INDEPENDENT ADVISORY
PANEL FOR UNDERGROUND
MINING

**DENDROBIUM COAL MINE
LONGWALLS 22 & 23
SUBSIDENCE MANAGEMENT PLAN**

March 2022

Figure 2: Plan showing longwall panels currently proposed in Area 3C and their spatial relationship to Cordeaux Dam, swamp Den7, tributaries LC5 and LC6, and Wongawilli Creek.

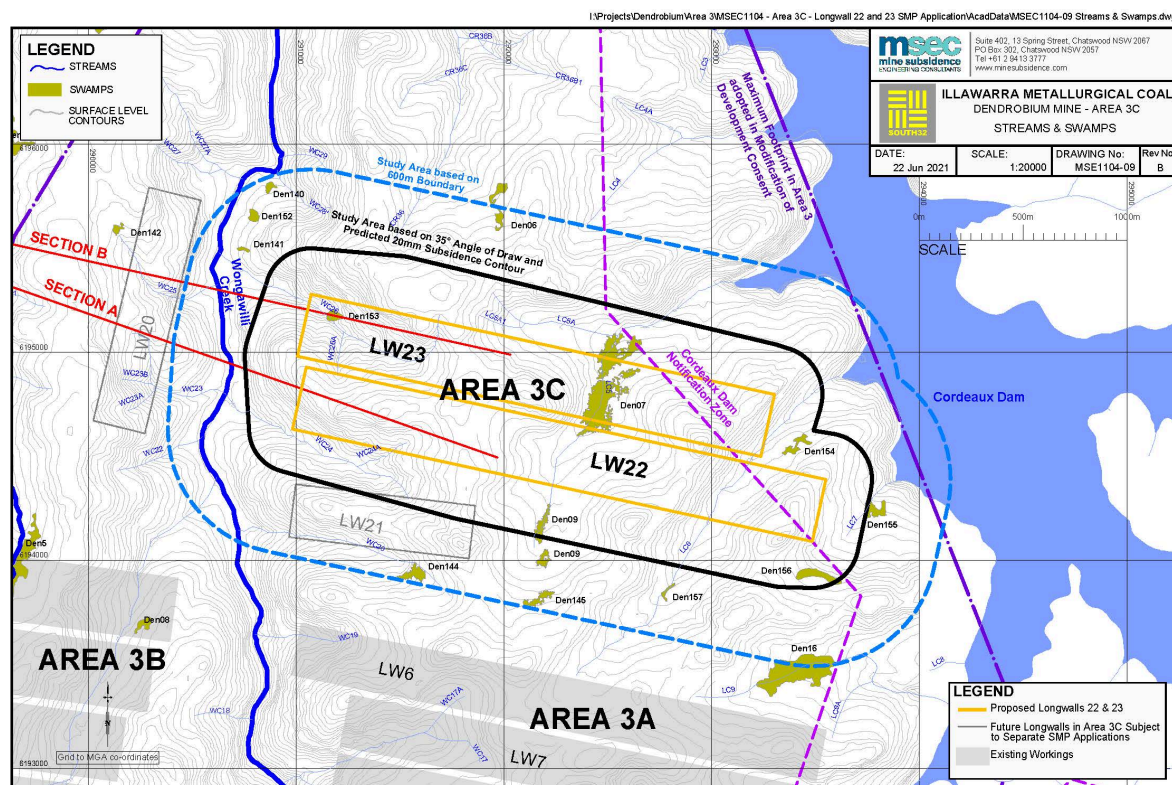
Figure 2 shows that LW20 is proposed to run near parallel and as close as around 150 m to Wongawilli Creek. These characteristics increase both the likelihood that Wongawilli Creek will be negatively impacted by LW20 and the length of Wongawilli Creek exposed to negative impacts. The Panel notes that the SMP for LW20 is yet to be approved.

Figure 3: Plan showing the concentration of geological structure (faults and dykes) adjacent to the southern flank of LW22, some of which extend under Cordeaux Reservoir.

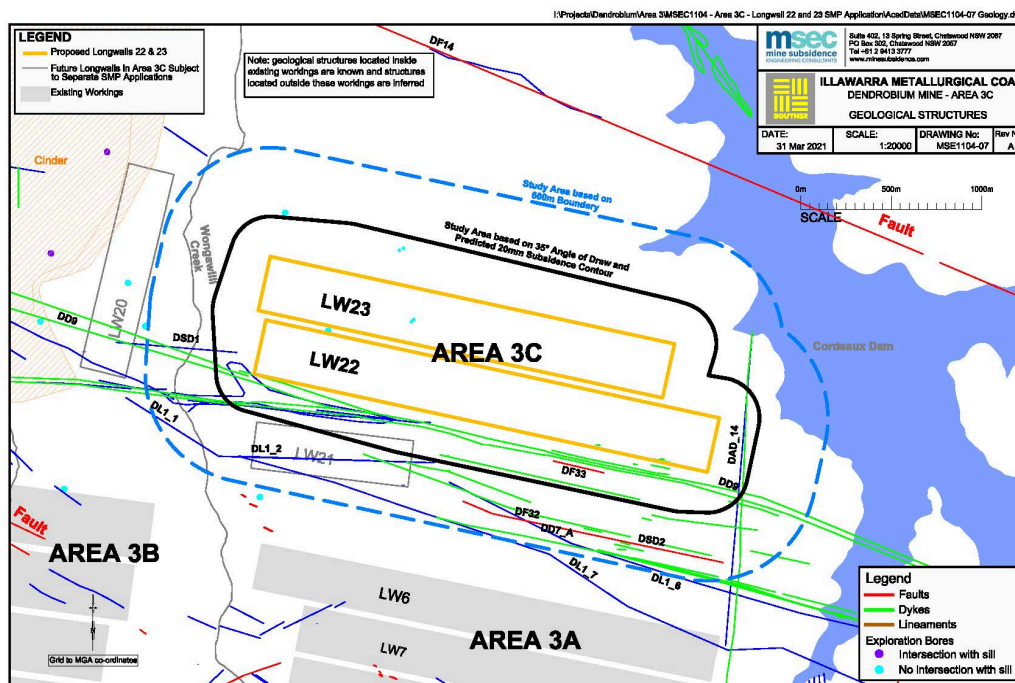
Figure 3 shows significant geological structures along the southern flank of LW22 and that some structures pass under Cordeaux Reservoir. It has been suggested in submissions that the mapping of geological structures is deficient and misleading.

Based on the information provided to the Panel, the Panel does not believe the mapping to be misleading or deficient. The issue appears to have arisen in large part due to a misunderstanding of what constitutes a lineament. In responding to submissions, South32 has advised that it has conducted substantial exploration in the areas over Longwalls 22 and 23 and has not confirmed any lineaments at seam level. Exploration datasets include surface vertical and surface-to-inseam boreholes, underground inseam drilling, seismic surveys, surface mapping and aeromagnetic surveys and these activities are ongoing. If structures are confirmed by these exploration techniques, South32 has committed to adding them to the seam structure layers. The Panel notes that the Risk Assessment also makes provision for responding to any unexpected structure encountered during mining.

Based on the information provide to it, the Panel is of the view that the potential for hydraulic connections associated with geological structures to extend from the stored waters to the mine workings is very low.

Figure 4: Time series of water levels at Pool 43A (now called Pool 50) (Source: End of Panel Report for LW17).

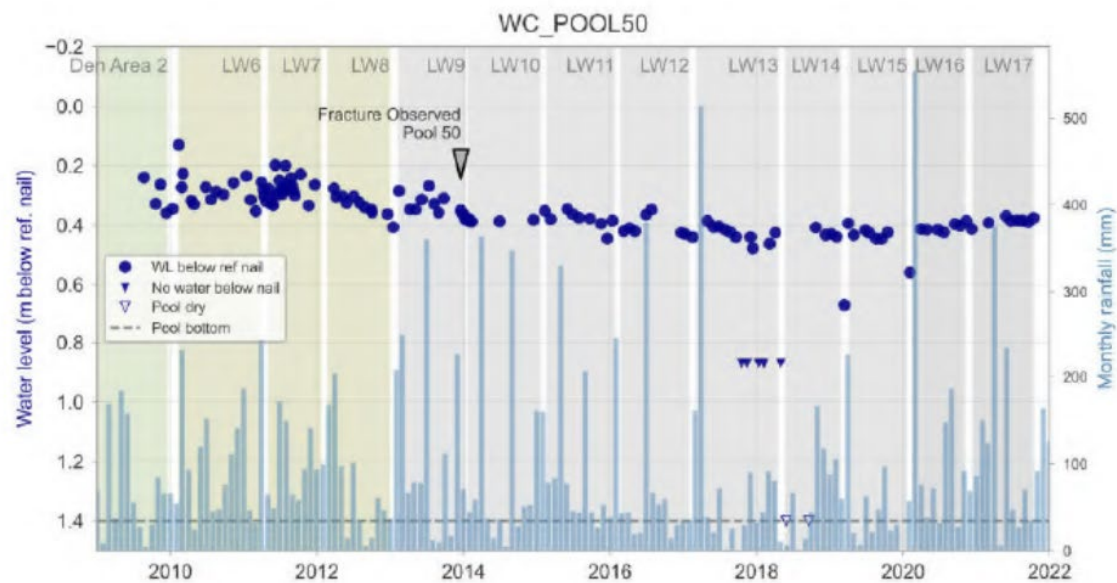
None of the performance measures explicitly extend to cases such as Pool 43A, where the dominant mining impact is pool level loss due to groundwater depressurisation. Pool water levels are reported and evaluated in End of Panel reports, in particular Pool 43A has received extensive attention as part of the TARP process. However, any loss of water level greater than minor, unless it is associated with a fracture, is not explicitly addressed by the Performance Measures. The Panel notes again that a change in pool level relative to maximum depth of the pool may not be the most appropriate measure of impact. A change relative to average pool depth or to baseline variation could be considered in setting future performance measures.

Figure 4: Profile showing the dominant contribution of LW20 to predicted valley closure (Source: South32 response to Panel's questions of 28/2/22).

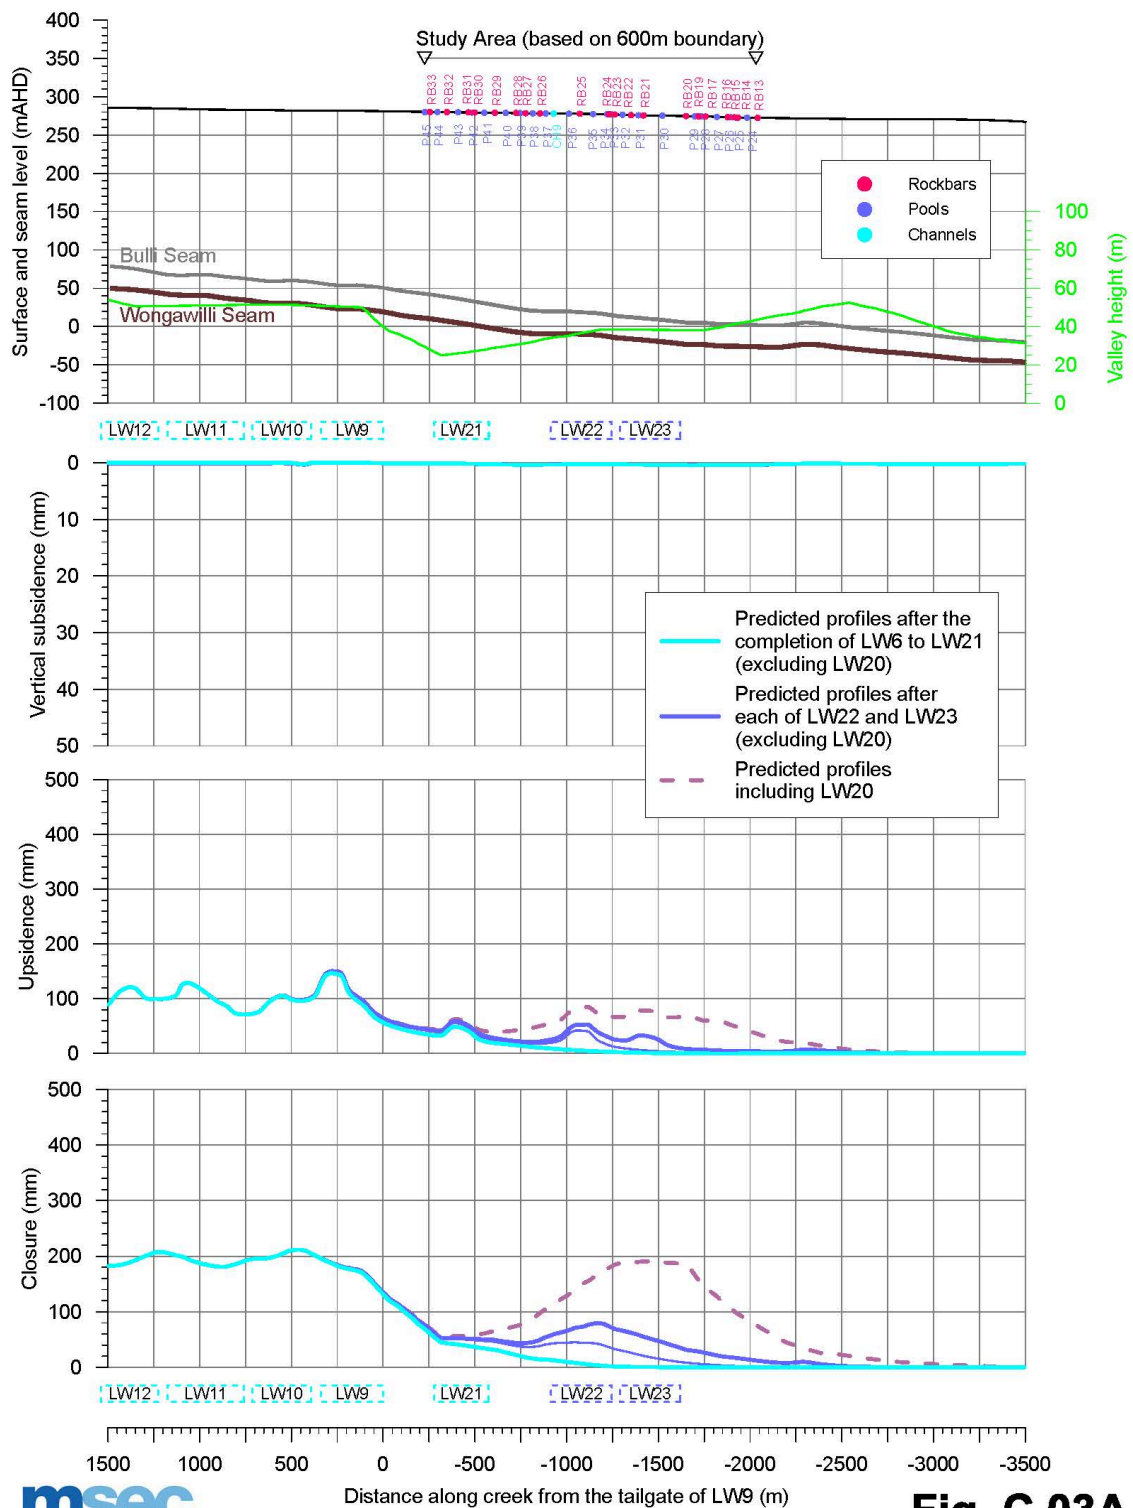
The Panel notes the case for LW22 and 23 is similar to that noted in the Reasons for Approval of LW19 in that for every additional 50 m setback, there may be a steep reduction in extractable coal volume but only a quite small reduction in the probability of Type 3 impacts. This is largely because previously mined or planned longwall panels account for much of the predicted valley closure that drives probability. This is illustrated in Figure 4 in the case of LW22 and 23, which shows that LW20 is the major contributor to predicted valley closure across Wongawilli Creek in the area.

- **The predictions of valley closure and associated Type 3 impact probability for LW22 & 23 assume the future mining of LW20 on the opposite, western, side of Wongawilli Creek. Analysing the benefit of further setbacks of LW22 & 23 from Wongawilli Creek may benefit from coincident review of the LW20 plan. Based on current knowledge, if LW20 were not to be extracted, the risk of Type 3 fracturing due to LW22 and 23 with their currently proposed setbacks is very low.**
